RE: Wastewater System Assessment for Your Development
Your Town, Minnesota

EcoCheck met with your operation staff on April 20 and 21 to assess the wastewater treatment system designed for the townhomes in your development (Units A, B D and F). The system was designed for a flow of 6,840 gallons in 1996 by Engineering Firm A. Your current operations staff informed EcoCheck of past issues with the frozen or cracked supply and return lines, biological build-up inside the drip irrigation emitters and other operational issues.

Figure 4: Supply and return line pipe diameters.

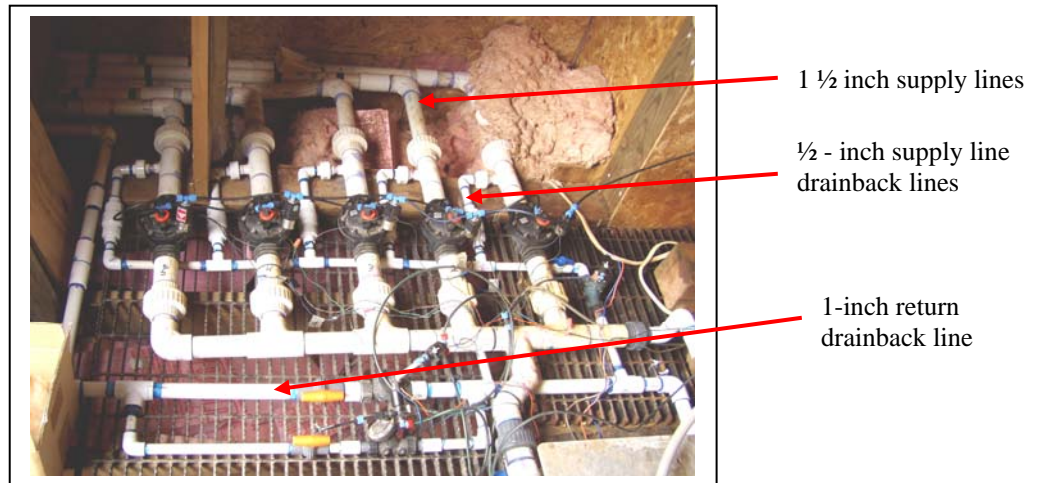
- b. The supply and return lines in the drip zones have a larger pipe diameter than at the drainback line (where all water in the system drains back to the settling tank). Both supply and return lines are 1-1/2 inches in diameter, yet when the lines connect near the control building, the supply line drainback is ½-inch diameter and the return line pipe diameter is reduced to 1-inch.

- c. In drip irrigation systems, it is important to drain the supply and return lines quickly to prevent the potential for line freezing. The current situation slows the drainback process and increases the freezing potential. This may be part of the reason why supply and header lines have become broken in the past.

Recommendation – To minimize freezing, EcoCheck believes the piping inside the control building should be modified to a larger diameter pipe (i.e. 3-4 inch in diameter). This should improve drainback time. Further, we believe an operational change should occur by not manually shutting off the valves outside of winter if plugging is occurring in the return lines (which can be confirmed by operational staff).

Figure 5: Head works of Zones 1-5 and supply and return lines.

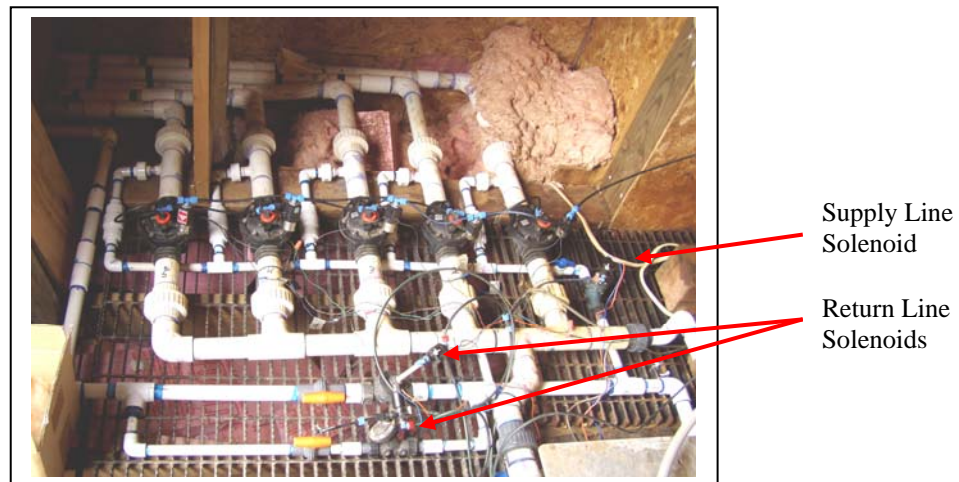
4. **Solenoid Operation** – It is difficult to tell whether the solenoid valves are opening or closing based upon the PLC logic. We attempted to do this, however in manual pumping mode, the solenoids do not operate unless the valves are opened in automatic mode by the PLC logic. Based upon observation during automatic operation, it appears the drainback valves are not opening or closing as they should be. When the pumps turn on, the supply and return valves should close (when not in flushing mode) and should open when the pumps turn off to allow for drainback. An output light is located on the PLC which does not light up when the valves open or close. Because of this, we believe the PLC is not communicating with the drainback solenoid valves.

Recommendation – An electrician should look at the PLC outputs and confirm solenoid operation for the supply and return lines.

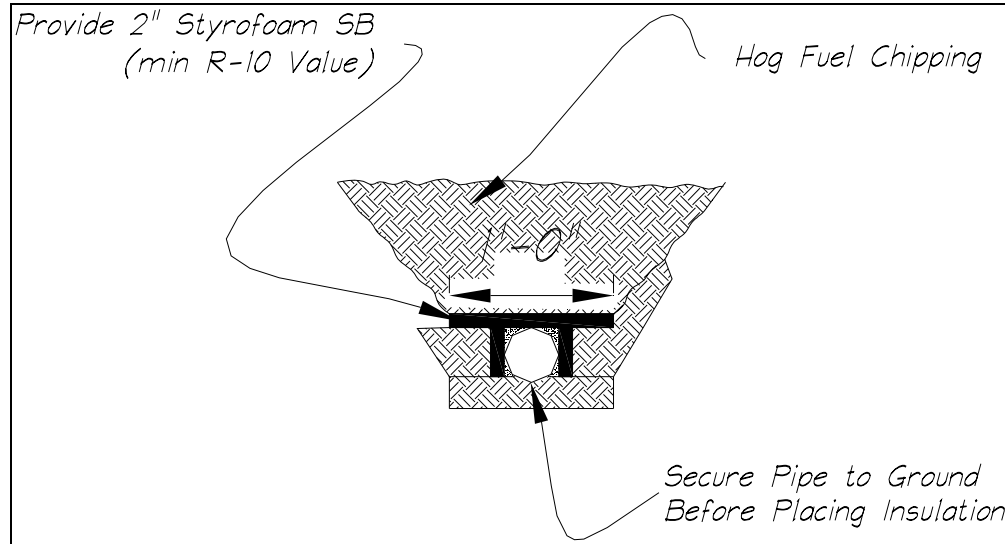
7. **Insulating Supply and Return Lines** – Several of the supply and return lines are exposed to the open environment and have not been buried. The operators have described issues with repairing pipe breaks in the supply and return lines. The broken lines may be occurring from recurring fill and drain cycles, causing ice sheeting on the inside of the pipes. This is the likely scenario since pipe breaks have occurred in areas that appeared to have adequate slope for drainback.

Recommendation – The supply and return lines should be secured to the ground by a U-Clamp, if it is lying on top of the ground. To minimize freezing potential, the operator should provide box insulation (as shown in the figure below) of all of the exposed pipe and cover the insulation with hogfuel.
